X-TYPE

XT501-08

TECHNICAL BULLETIN

Passenger Footwell Water Leakage –
Leakage At Pollen Filter Housing –
Install Water Shield

ILLUSTRATION 1

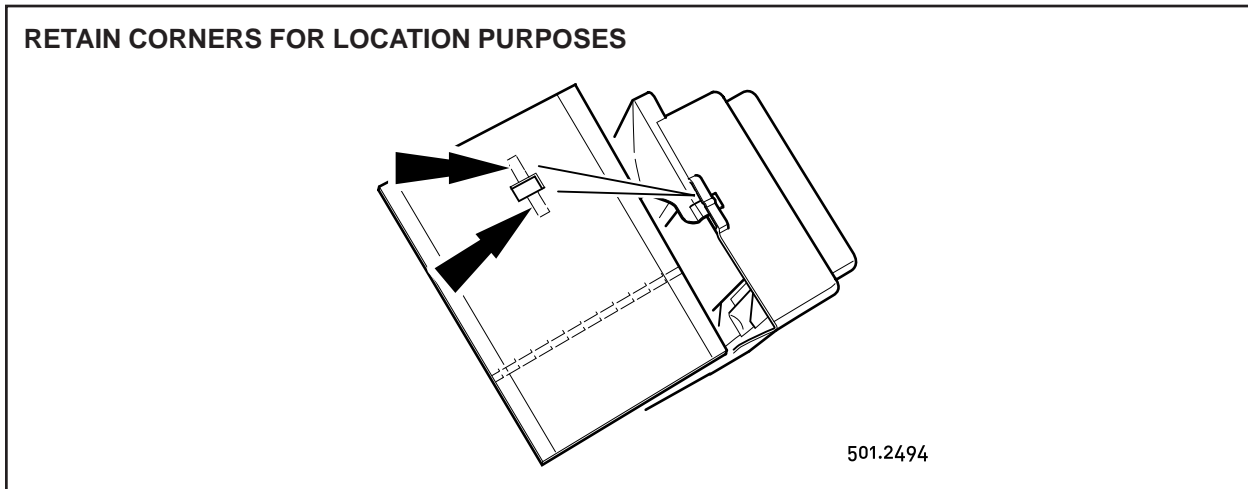
6. For pollen filter housings with a double slot, cut and remove material from water shield (Illustration 1).

Note: Ensure that the four corners of the original cutout remain for location purposes.

Note: Sufficient material should be removed to allow water shield to seal flat against housing.

ILLUSTRATION 2

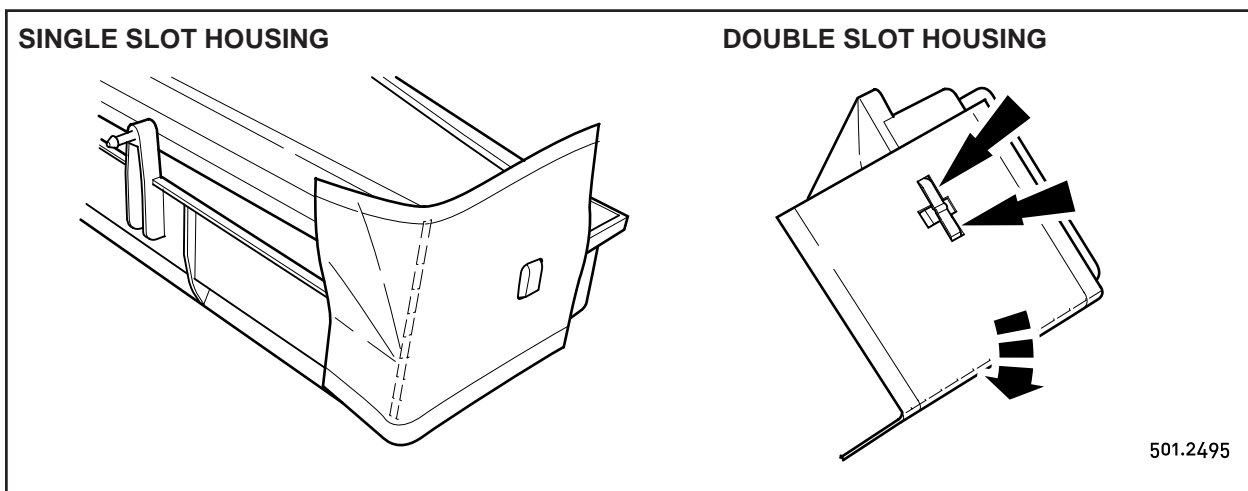
7. Remove and discard backing paper from water shield, align and affix water shield to pollen filter housing. (Illustration 2 if single slot pollen filter housing) (Illustration 3 if double slot pollen filter housing).
